**EVAPORATION
PONDS CA**

From: Chavez, Carl J, EMNRD
Sent: Tuesday, November 27, 2018 2:39 PM
To: Combs, Robert (Robert.Combs@hollyfrontier.com)
Cc: Griswold, Jim, EMNRD; Combs, Robert (Robert.Combs@hollyfrontier.com); Cobrain, Dave, NMENV; Tsinnajinnie, Leona, NMENV
Subject: RE: EP area Test Wells Plugging Plans

**RE: Work Plan for Abandonment of Former “Test” Wells:
HollyFrontier Navajo Refining LLC – Artesia Refinery**

wood. | **FIGURE 1**

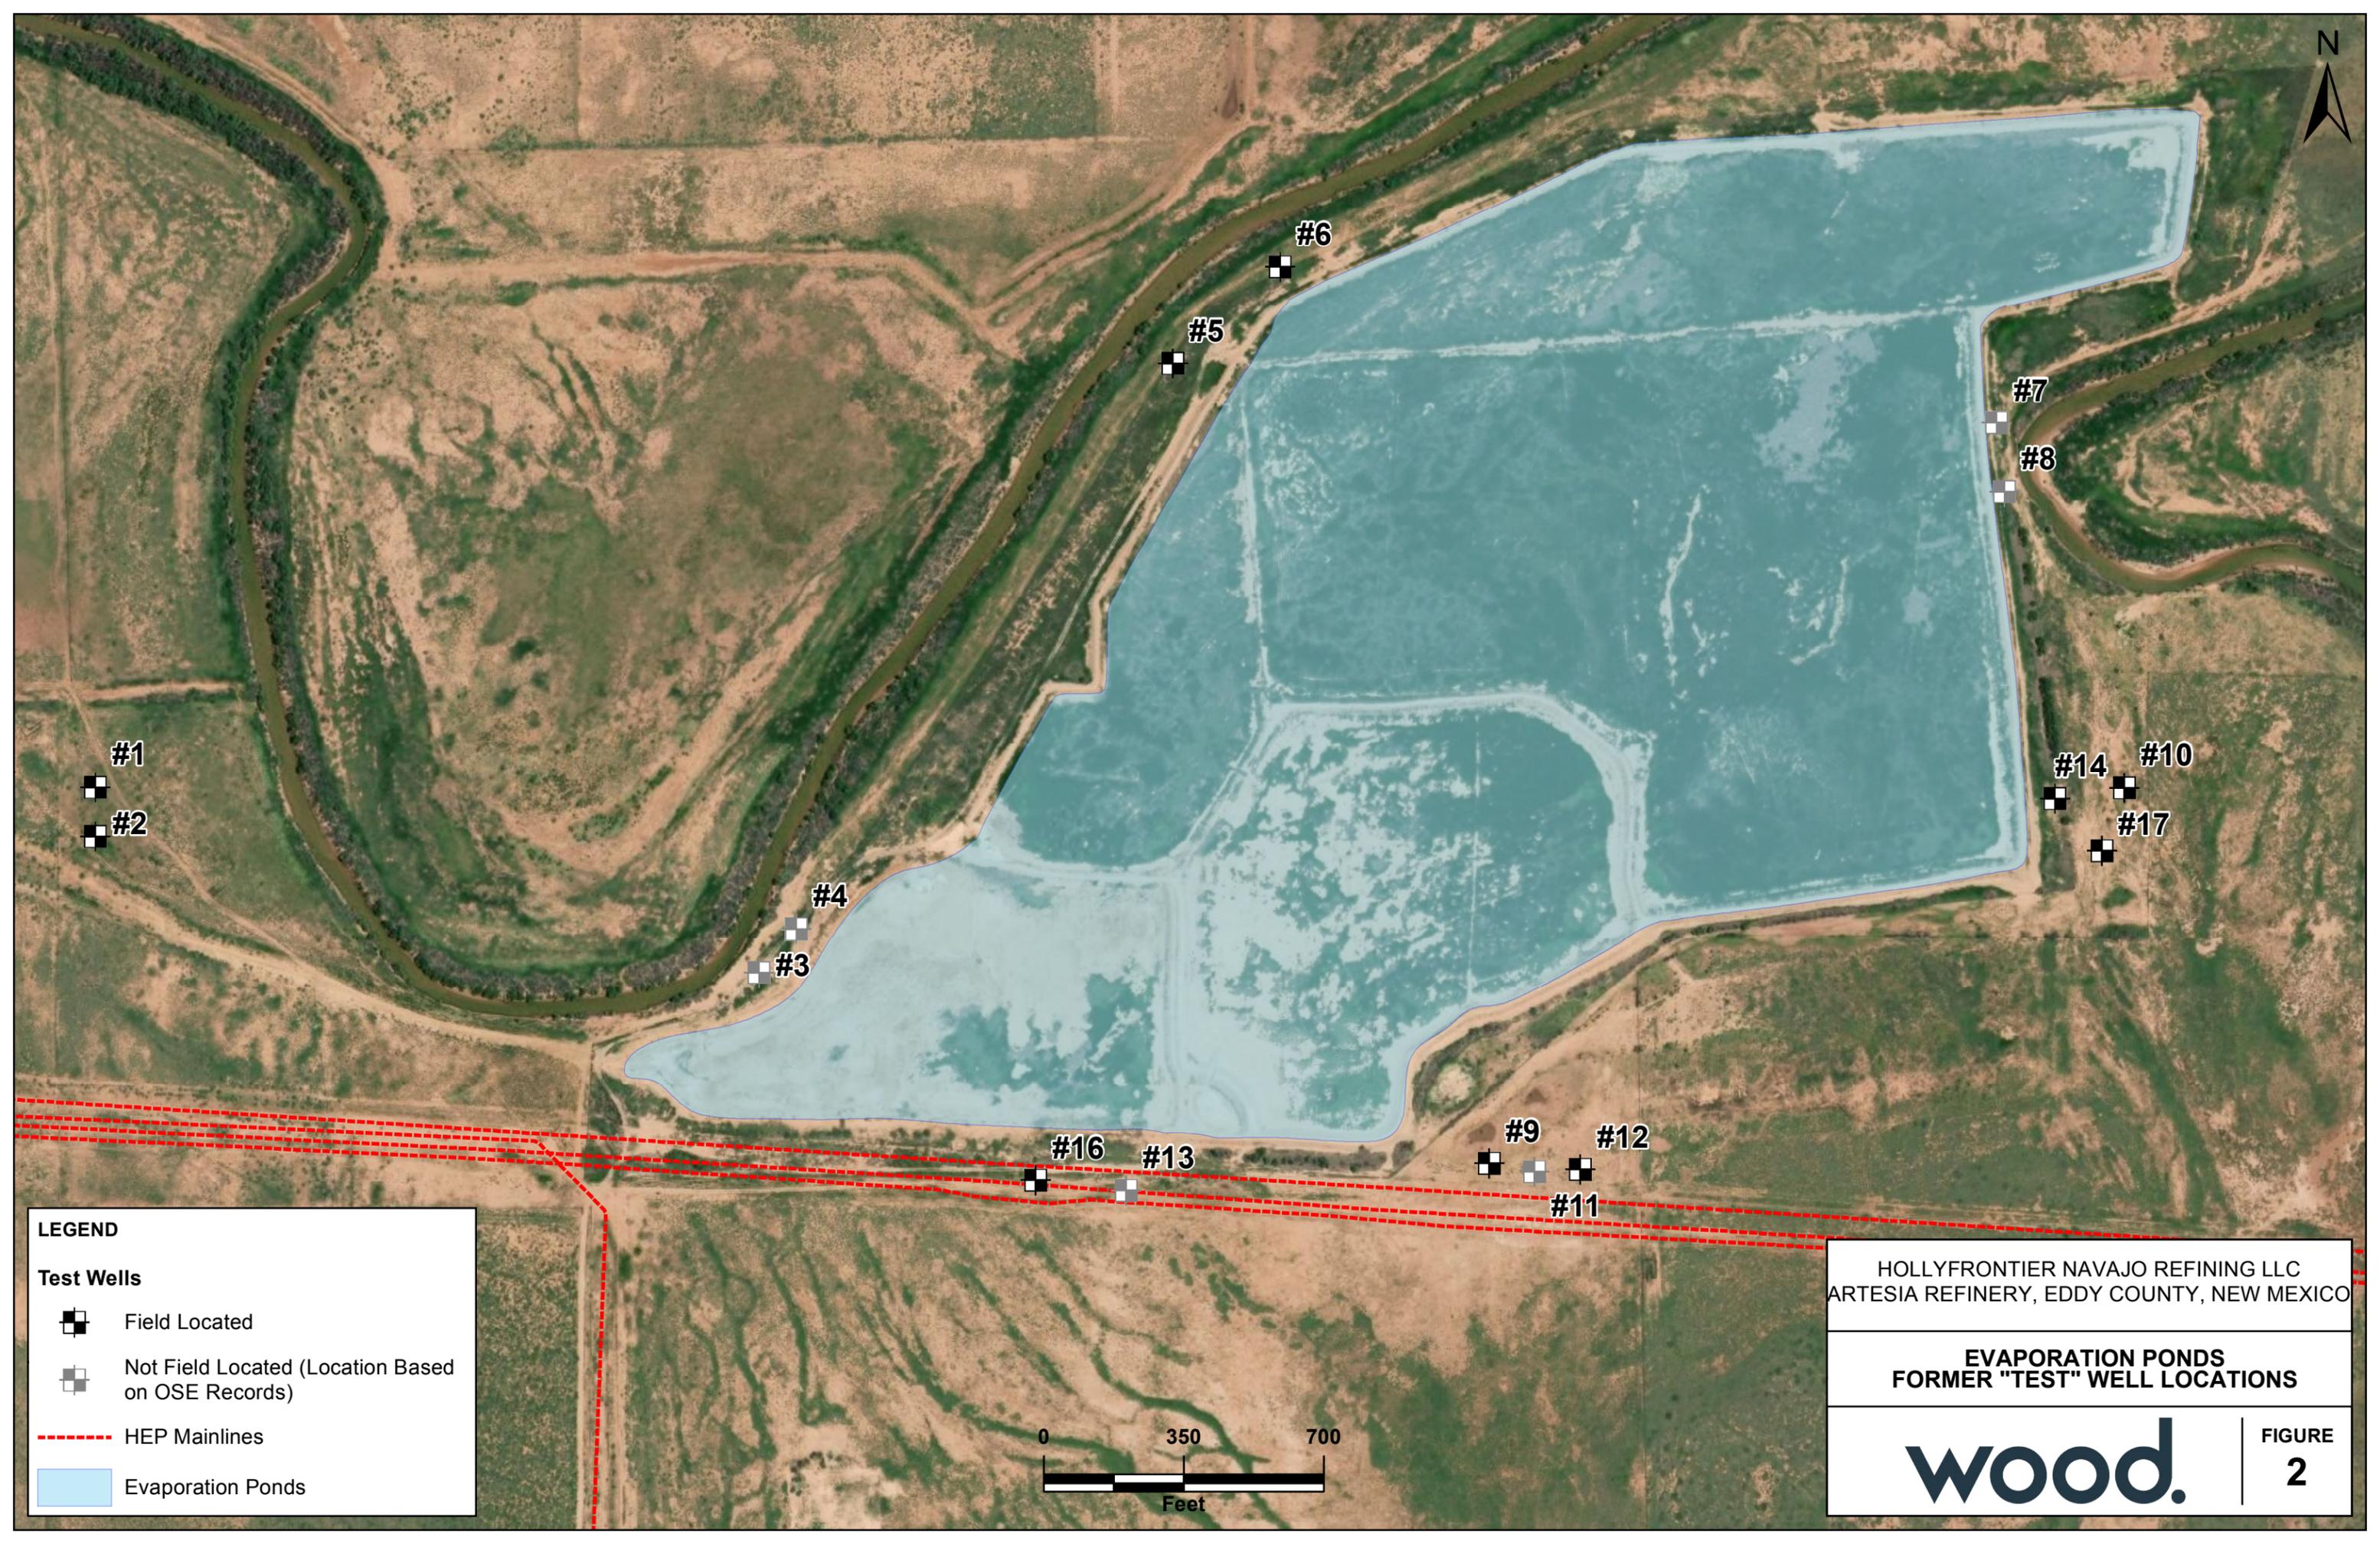
In Figures 1 (Site Location Map), 2 (Evaporation Ponds) and all figures in Appendix A (Updated Lithologic Cross-Sections and Presentation of Analytical Data on Cross-Sections), the Permittee uses the incorrect title, "Evaporation Ponds Phase III CAI Report." In future work plans and reports, ensure the titles of each figure reference the subject work plan or report. No revision necessary.
